## Aachen Cathedral (Germany)

### No 3bis

#### 1 Basic data

Map showing the boundaries of the proposed buffer zone

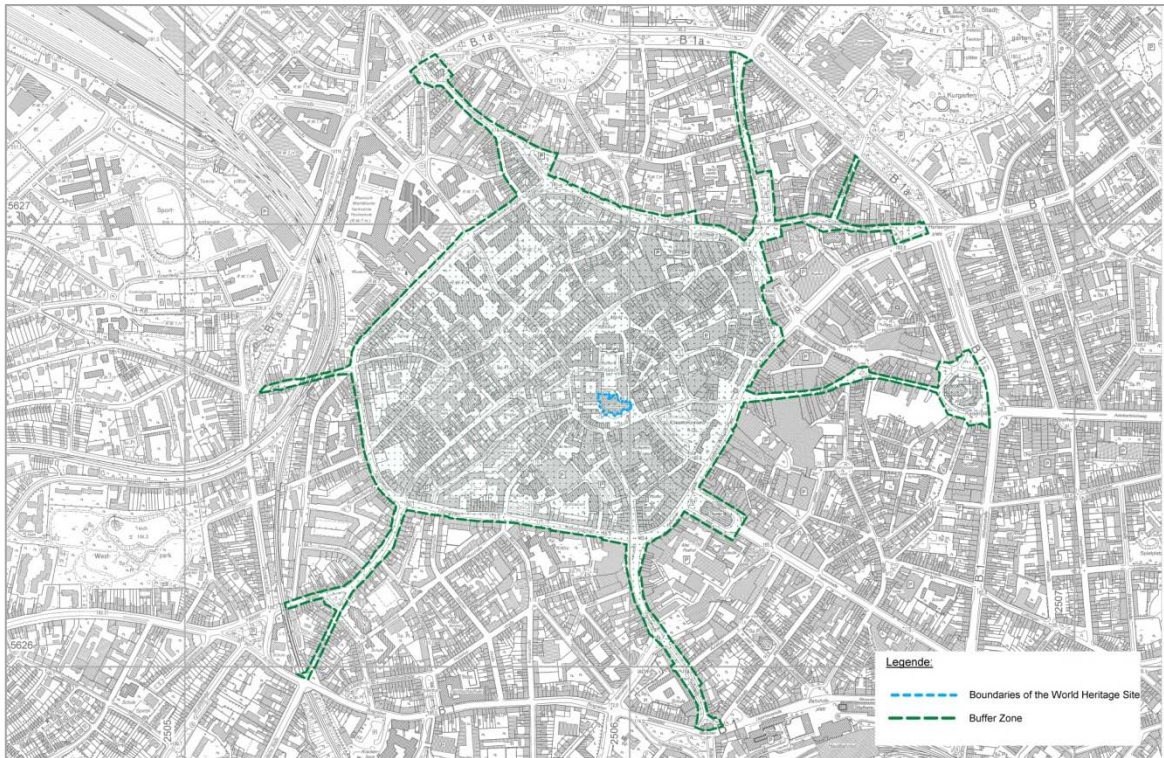
However ICOMOS notes that the streets and the monuments lying beyond the city inner ring road have not been specifically mentioned in the minor boundary modification dossier.

ICOMOS further observes that it is important that the State Party explains in more detail how the protection zones 1 and 2 function, and which protection measures have been established to safeguard the views over the inscribed property and the related monumental complex.

Finally the State Party has not explained how these provisions relate to the existing legal and planning framework, and what are the management implications should the buffer zone be approved, i.e. which authority will be responsible for the implementation of protection measures within the buffer zone, and how this authority will relate to and coordinate with the body responsible for the inscribed property.

- Explain the rationale which guided the inclusion within the buffer zone of some streets and monuments located outside the city inner ring road;
- Explain in more detail how the protection zones 1 and 2 functions and which protection measures have been established to safeguard the views over the inscribed property and the related monumental complex and clarify how these regulations relate to the existing legal and/or planning framework;
- Explain which will be the authority responsible for the implementation of these regulations within the buffer zone and how this authority will coordinate with the body responsible for the inscribed property.
